**PLANNED UNIT DEVELOPMENT  
& SUBDIVISION STAFF REPORT****Date: December 18, 2008**

| <b><u>SUBDIVISION NAME</u></b>                  | Saint Augustine Subdivision, Resubdivision of   |
| <b><u>CONTEMPLATED USE</u></b>                  | Planned Unit Development Approval to allow shared<br>access and parking between two building sites and Subdivision approval to create two legal lots<br>of record from a legal lot and a metes and bounds parcel.                           |

# SITE PLAN

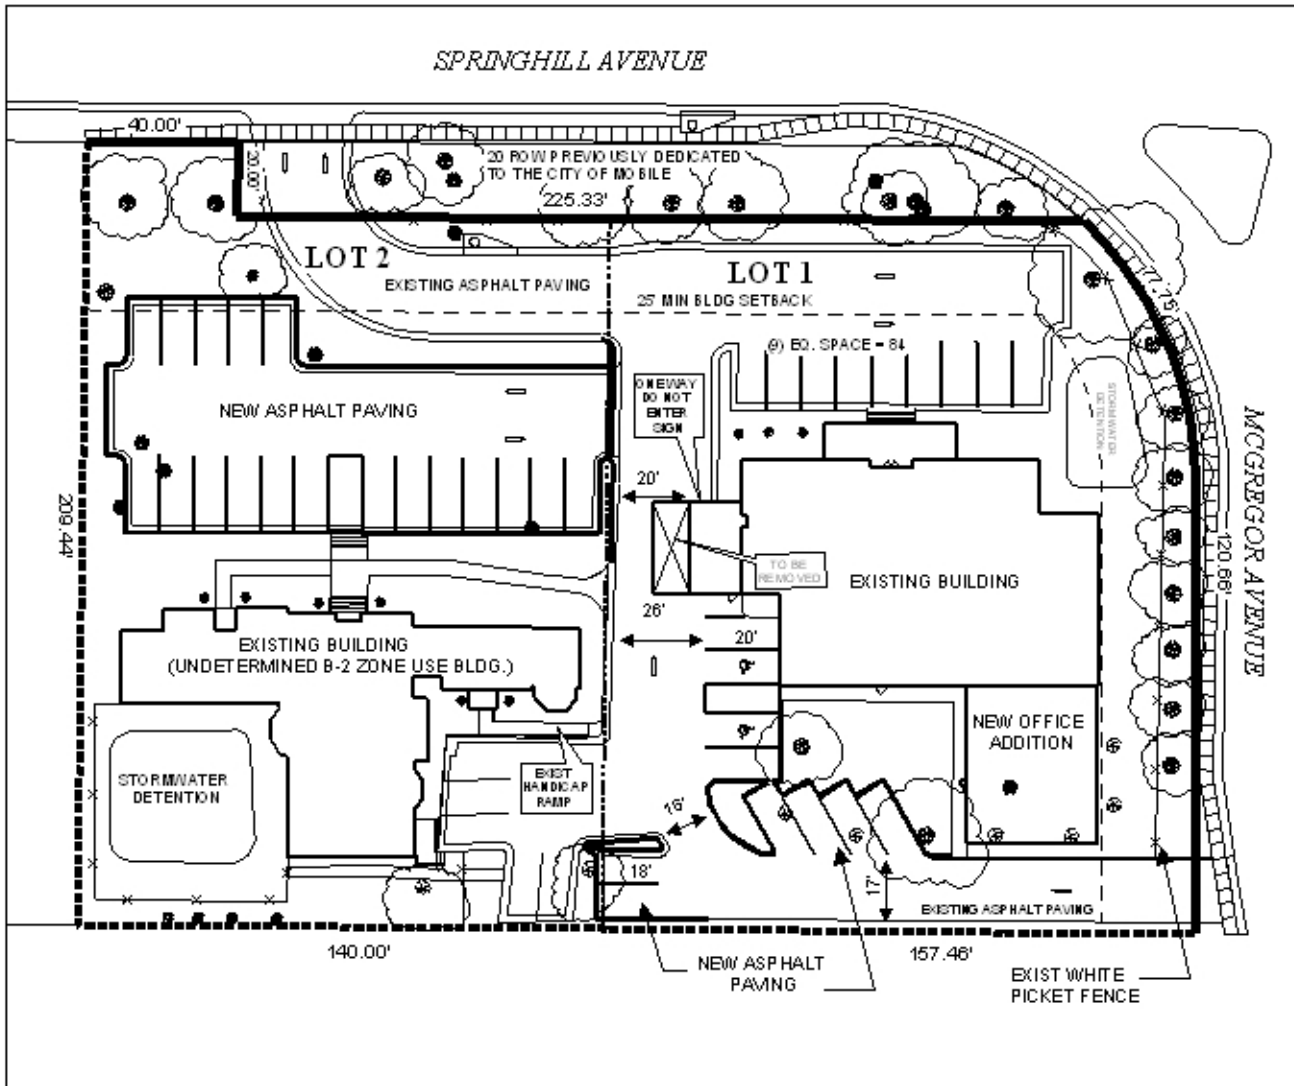
Access management is a concern; due to the location at the intersection of two major streets; however, the applicant is proposing one 24-foot wide two-way, curb cut along Springhill Avenue and an approximately 16-foot one-way (entrance), curb cut on McGregor Avenue, which should be sufficient for the number of parking spaces provided on site. However, the site plan should be revised to illustrate the curbing and radius for this curb cut, it should also be signed as one-way entrance only as well.

The applicant is proposing a redevelopment of an existing 5,798 square-foot preschool and daycare facility to an Engineering/Architectural office on Lot 1, the applicant proposes the addition of approximately 1,237 square-feet office space to support staffing for the professional business. The applicant proposes to lease the 4,068 square-foot building on Lot 2 for businesses consistent with B-2 zoning. Since both lots will share access/parking, the total provided (42) parking spaces exceed the 37 spaces that are required by the Zoning Ordinance.

Furthermore, compliance with the tree and landscaping requirements of the Zoning Ordinance will be required. Information on the site plan indicates that adequate area will be available for compliance with the landscaping and tree requirements of the Zoning Ordinance. It should be noted that the trees planted (along Springhill Avenue) to comply with the ordinance from a previous development may not meet the requirements as illustrated, since they are not located

within the dedicated right-of-way. However, staff does allow the reduction of the existing linear feet along Springhill Avenue covered by the canopy of existing trees along this section of dedicated right-of-way. Therefore, the planting of additional trees may be required to meet the requirements of the Ordinance.

It should be noted that the applicant states and noted on the site plan that trash collection will be by private trash pick-up firm and that no dumpster will be provided. However, if a dumpster will be provided it must meet the setback and buffering requirements of the Ordinance.

**Planned Unit Development:** Based upon the revised PUD site plan, this application is recommended for Approval, subject to the following:

- 1) labeling of all detention/retention areas, and placement of a note on the site plan and Final Plat stating that maintenance of detention/retention areas is the responsibility of the property owners;
- 2) full compliance with the Tree Planting requirements of the Ordinance;
- 3) placement of a note on the site plan and Final Plat stating that the site must be developed in compliance with all local, state and Federal regulations regarding endangered, threatened or otherwise protected species;
- 4) the provision that if a dumpster is provided, it must meet the setback and buffering requirements of the Ordinance;
- 5) provision of two (2) revised PUD site plans to the Planning Section of Urban Development prior to the signing of any Subdivision plat; and
- 6) full compliance with all other municipal codes and ordinances.
